### **AMENDMENTS TO THE DRAWINGS**

U.S. Application Serial No. 10/693,329  
Attorney Docket: 46675-0005  
Reply to Office Action of August 23, 2005

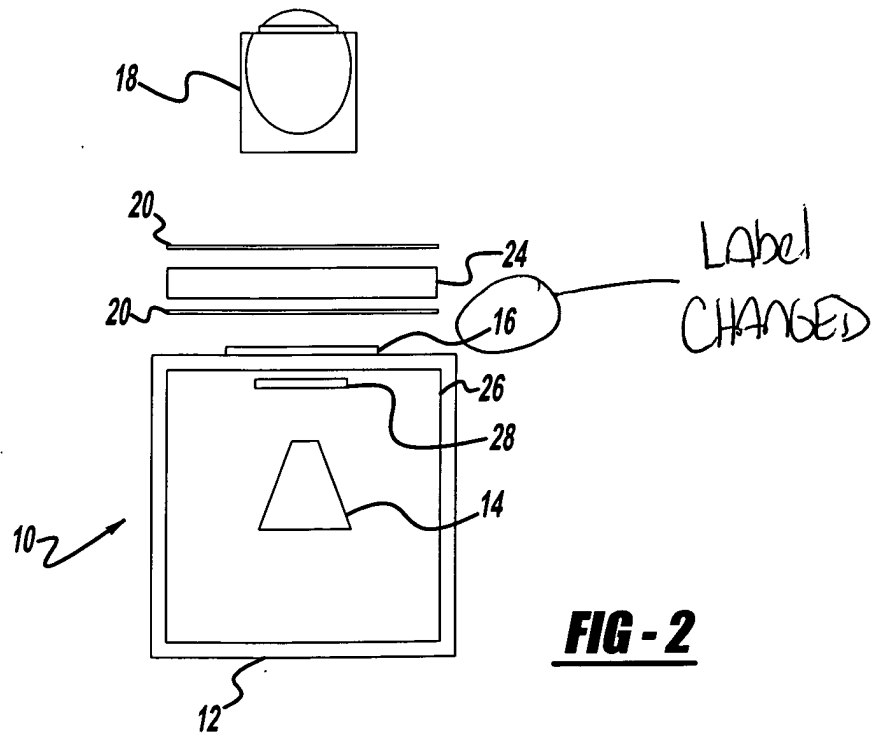
The attached sheets of drawings include changes to Figures 1, 2 and 4-6 and replace the original sheets. In Figure 1, previously mislabeled element 15 has been changed to 16. In Figure 2, previously mislabeled element 10 has been changed to 16. In Figures 4-6, element 34 has been reinserted into the formalized drawings. Furthermore, arrow 40 has been added to Figures 4 and 5.

The Examiner has objected to the drawings for failing to comply with 37 CFR 1.84(p)(5) and 37 CFR 1.84 (p)(4) for various reasons. Applicant has amended the drawings as follows: (i) in Figure 1, previously mislabeled element 15 has been changed to 16, (ii) in Figure 2, previously mislabeled element 10 has been changed to 16, (iii) in Figures 4-6, element 34 has been reinserted into the formalized drawings (which was included in the figures originally filed with this application), and (iv) arrow 40 has been added to Figures 4 and 5. Applicant respectfully requests that the Examiner withdraw his objections to the drawings.
